## ***Interactive comment on “Behavior analysis by model slope experiment of artificial rainfall” by M. C. Park***

Received and published: 28 September 2015

Anonymous Referee #1

Fig. 1.

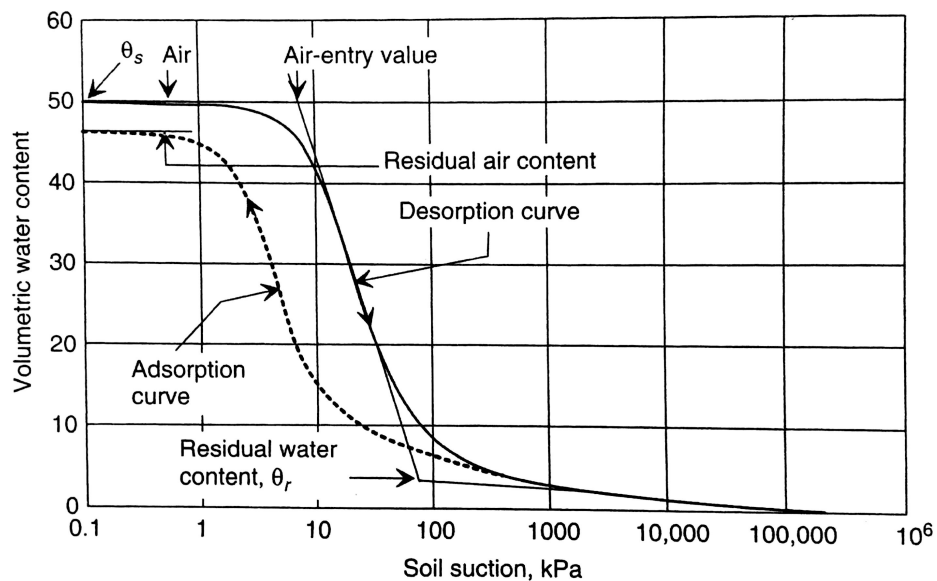
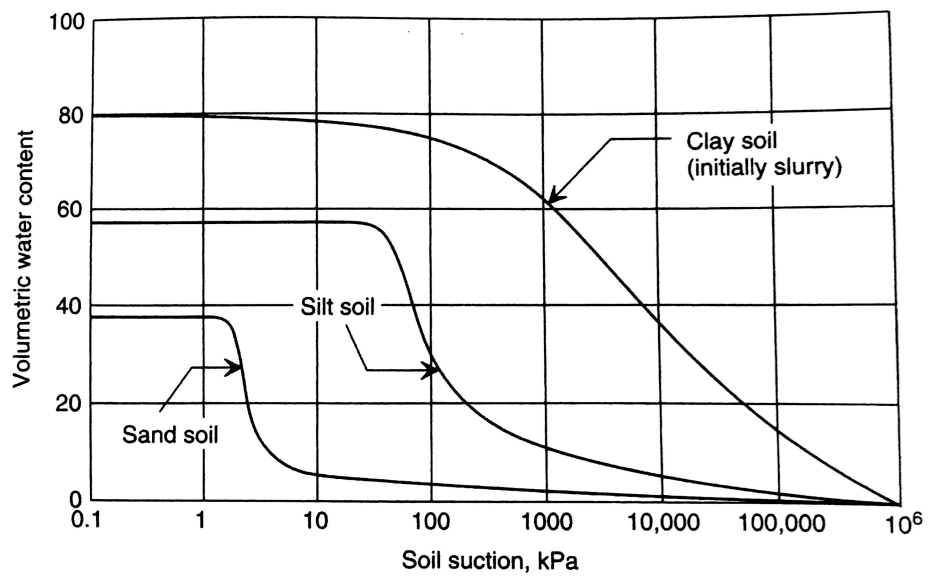
Question : The last point regards the interpretation of the soil parameters. The authors assign an air-entry value of 0.452, which is quite suspect. As far as I know, the air-entry value should be the point where air enters in the pore, i.e., the point where the curve deviates from the saturation. In the fitting of the data, this point is very close to the origin, which means that the material practically does not have any capillarity fringe (that is normal, indeed). Therefore, the air entry value should be low, almost 0, in my opinion.

- Answer : For seepage analysis, these are required the residual water content  $\theta_r$ , the air entry pressure  $u_b$ , and the pore size distribution parameter  $n$ . The SWRCs were obtained from the pressure plate tests and fit to the van Genuchten model using the RETC code (Van Genuchten, 1980). Also, the air-entry value is also very similar compared to the figure below from the reference. It is a different value depending on the state of the soil, an air-entry value of 0.452 will not be a problem.
